La Costanera Restaurant, 8150 Cabrillo Highway
Consent Agreement CCC-17-CD-01
Public viewing area plan 6/8/2017

Sept 26, 2017
Comments by Lisa Ketcham
Chair, Midcoast Community Council

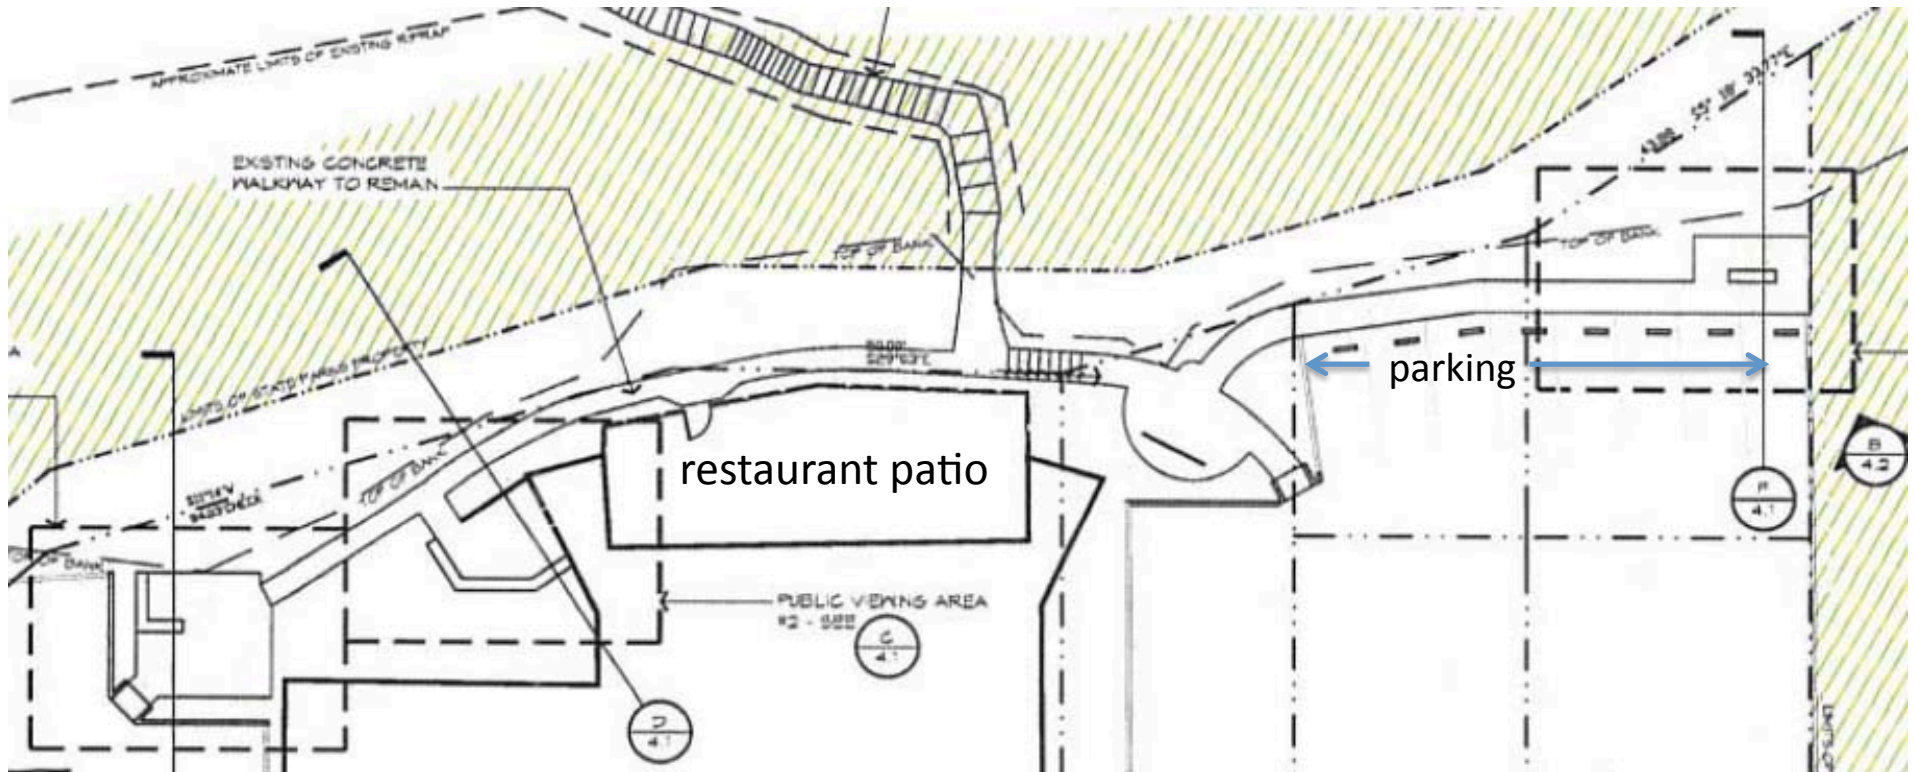
Plan proposes existing vegetation to remain west of the Coastal Trail at viewing areas. There is no mention of the view-blocking riprap boulders on top of bluff at the seating and parking view areas, and large view-blocking non-native shrubs invading the riprap, or the degraded landscape conditions in this area, increasingly infested with noxious weeds.

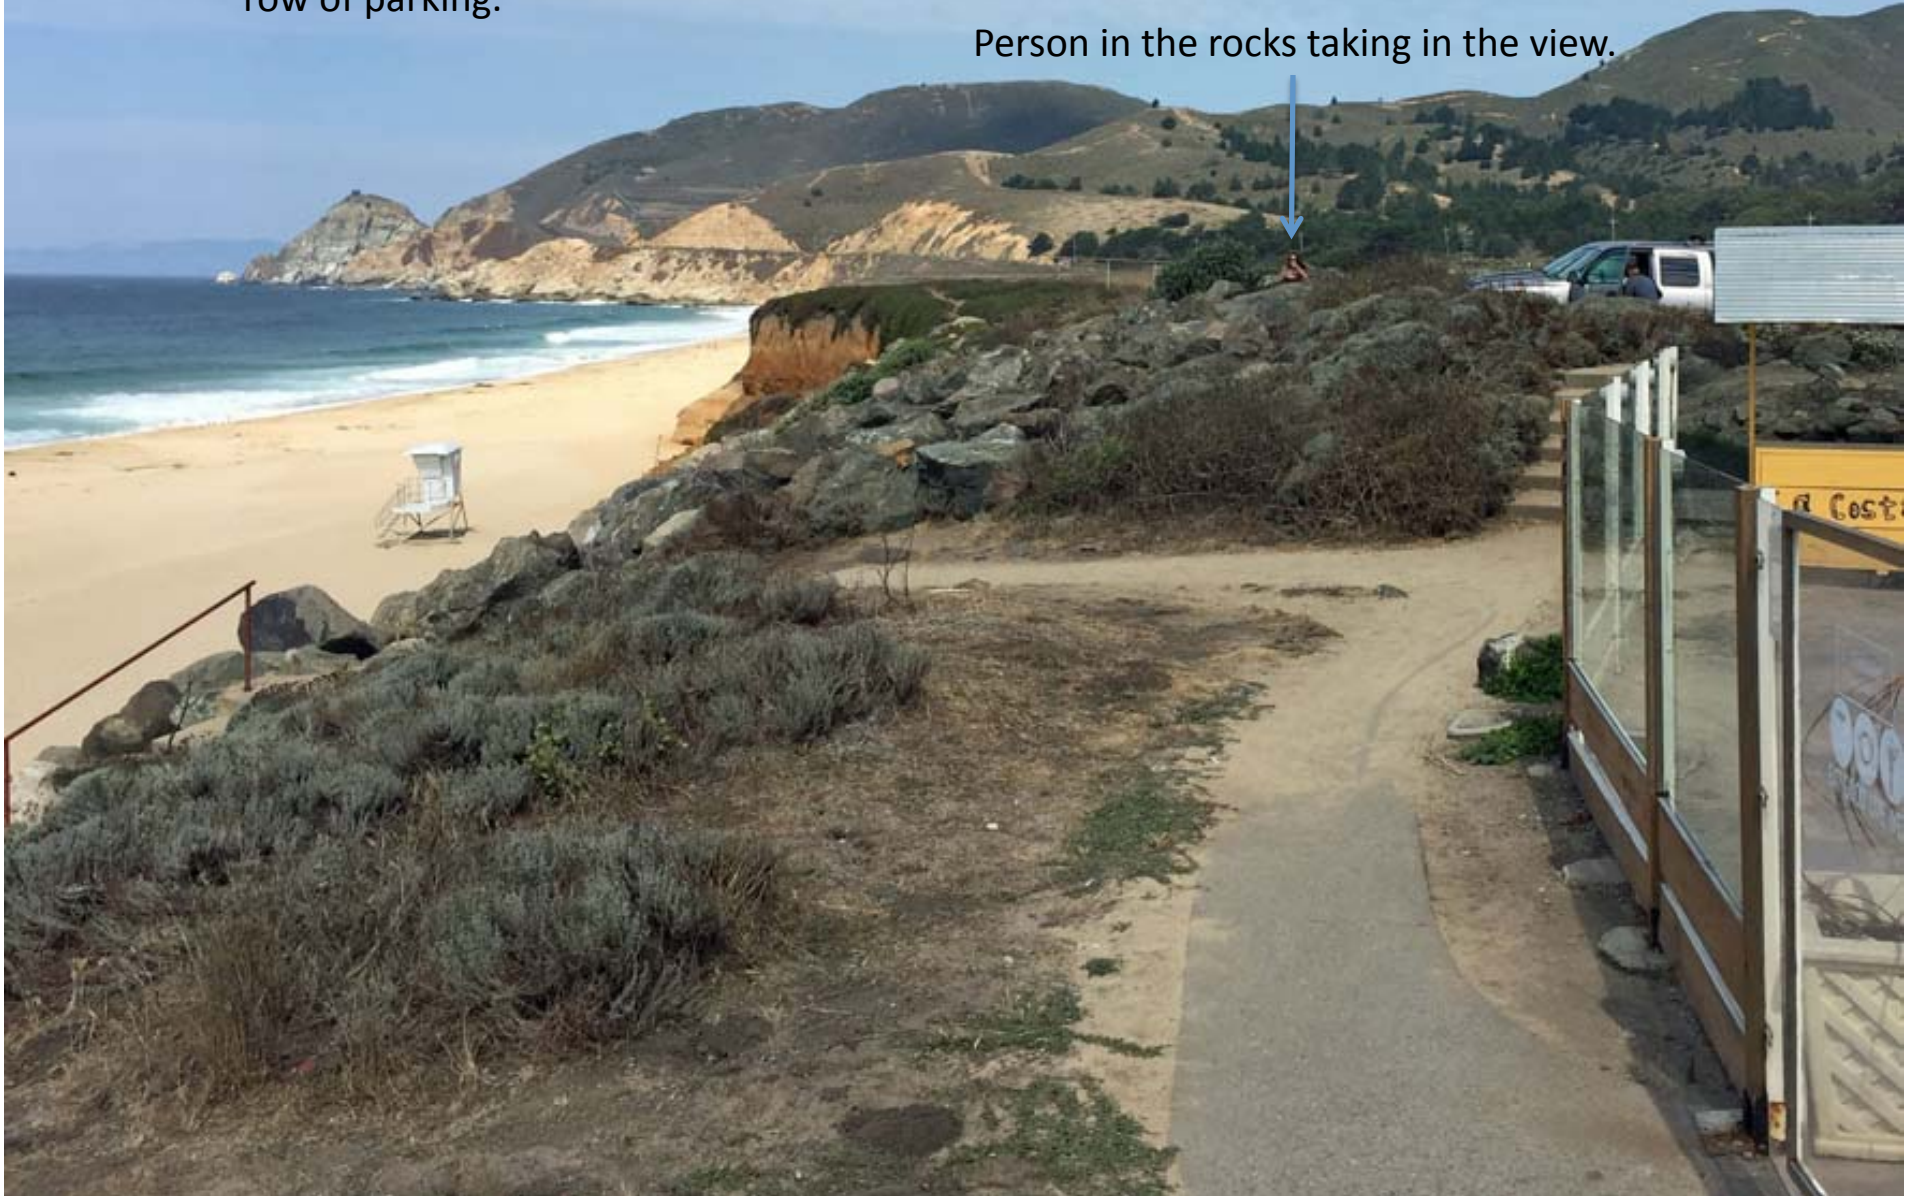
Riprap extends onto top of bluff, far beyond where needed for erosion protection, blocking public access and views. Plan cross-sections of the riprap are conceptual, showing an even gentle slope, but in reality the slope is much steeper along the bottom, and more level along the top.

Red line marks the upper reach of armoring boulders in front of the restaurant, which has no view obstruction.

The area seaward of the restaurant patio is clear of view-blocking boulders and tall shrubs. The same should be done for the public viewing areas and ocean-side row of parking.

Beach visitors, whether seated on the proposed viewing benches or in their cars due to cold or inclement weather, want to see the sand and surf zone. Currently they have to stand and walk through the boulders and noxious weeds in order to see over the riprap needlessly placed on top of the bluff.

Sight line to the shoreline from benches and seaward row of parked cars should be cleared of boulders.

Landscaping west of the restaurant and parking lots should not block beach views.

Invasive shrubs block view of promontory to the south from new viewing bench.

Tall-growing invasive shrubs increasingly block the beach view.
